Chehalis Basin Strategy

Phase 3 Landslide Evaluation

RE: Comments on Phase 3 Landslide Evaluation Draft Report from Department of Ecology Dam Safety Office – Shannon & Wilson response

Figure 4
FRE Reservoir Inundation and Drawdown Curves Used for Stability Analysis, 100-Year Flood

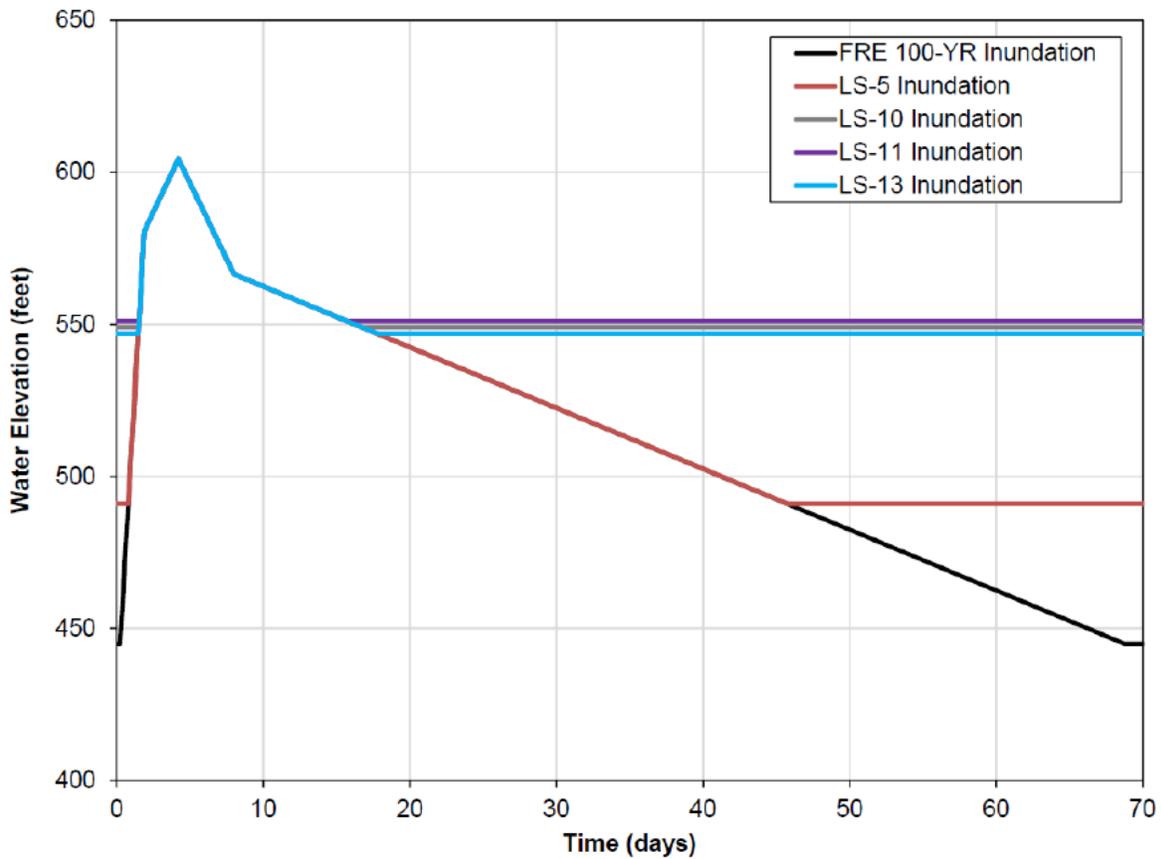
- 1) The analyses were conducted for the 100-year flood event. The report does not provide information explaining the reasons for selecting this specific flood event. The report should also explain how the 100-year flood event compares to other recent, significant flood events such as those of 1996, 2007, and 2009. This comparison should help to determine if a different flood event should also be considered in the stability analyses.

Comparisons of flood events are presented in the Operations Plan prepared by Anchor QEA (2017).

Language has been added to the report stating why the 100-year flood event was selected. The hydraulic and operations plan reports prepared for the Project should be referred to understand the relationship between the 100-year flood and historic flood events.

SEEP/W Seepage Mesh Size Influence on Calculated Factor of Safety for LS-5

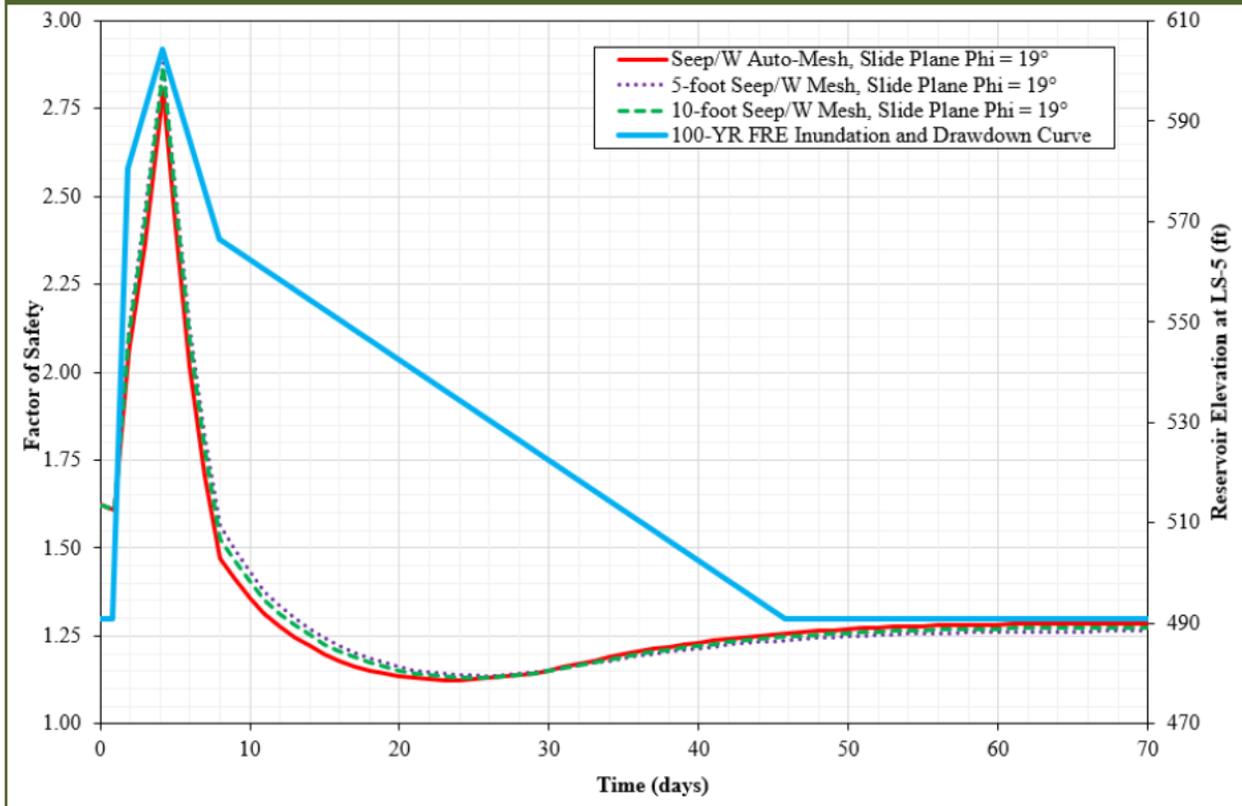
Comment 5:

To respond to this comment, we performed additional SEEP/W analyses of landslide LS-5 to compare stability analyses results obtained using the relatively coarse mesh automatically generated by the SEEP/W program (about 10 to 20 feet maximum dimension elements) with stability analyses results obtained using finer finite element meshes (5 and 10 feet maximum dimension). The automatically generated coarser mesh was used for seepage analyses of landforms and landslides evaluated in the draft of this report and Shannon & Wilson (2017a, 2017b).

Discussion and results of these analyses of the effect of mesh size on stability analyses results are included in the final report. The analyses results show the minimum computed FS during rapid drawdown, computed using the automatically generated coarse mesh, is within 2% of the minimum FS computed using the finer finite element meshes. This difference is not deemed significant. Therefore, the stability analyses results that rely on the seepage analyses performed using the coarser finite element mesh are applicable.
